Development Address: 600 River Ave

Project Description: 4015Q. FT. WALL MOUNTED BUSINESS ID SIGN

Zone Case #56. of 2020

Re: DCP-ZDR-2020-00686: 600 RIVER AVE

ELEVATION (VIEWED FROM ROOF)

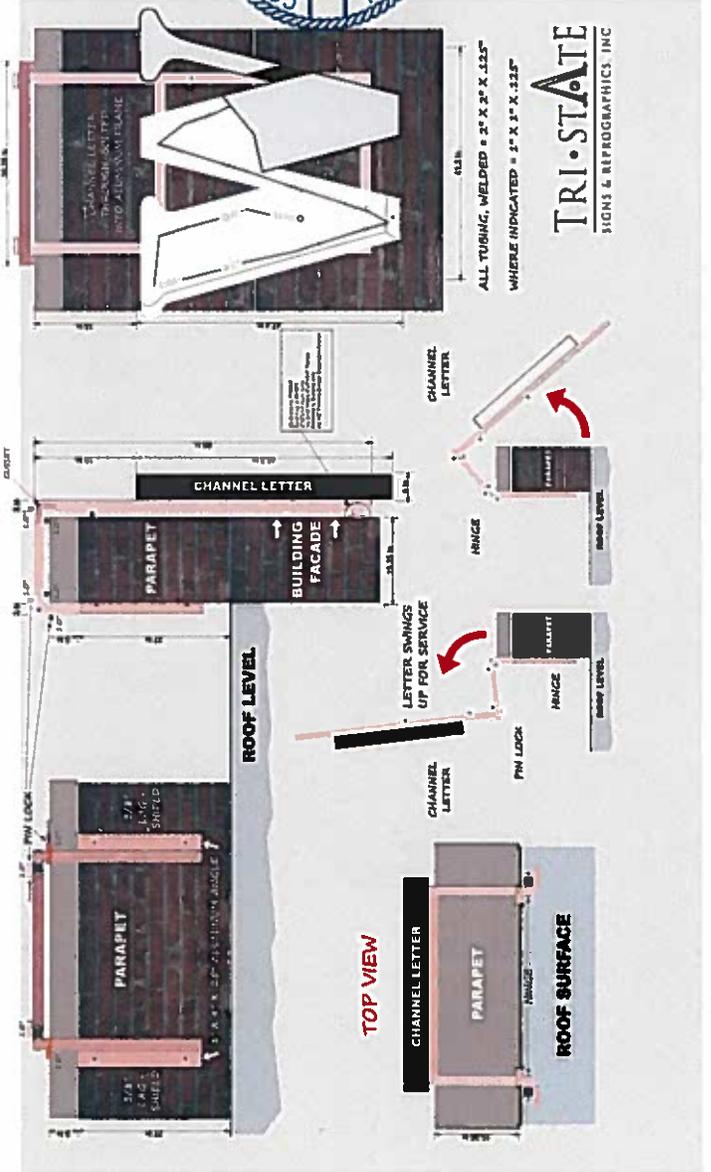
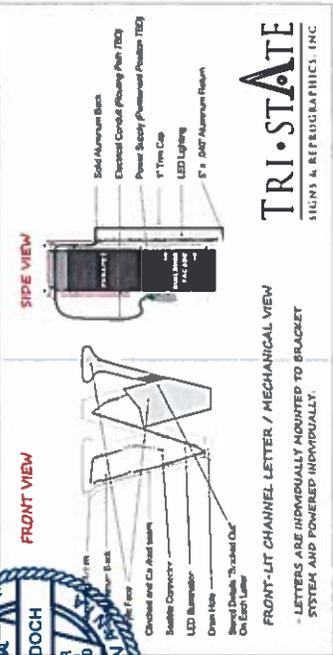
The Wounded Warrior Project logo appears to be above the parapet wall, which is Prohibited per 919.01.E.6. This will require a variance through the Zoning Board of Adjustment.

Additionally, it appears this was applied for initially on 17-SGN-00137 as a reface. It appears that the Confluence sign was taken fully down, so it cannot be permitted administratively.

Per 921.03.F, Nonconforming signs may not be enlarged, added to or replaced by another nonconforming sign or by a nonconforming use or structure, except that the substitution or interchange of poster panels and painted boards on nonconforming signs shall be permitted. So this will also require a variance.
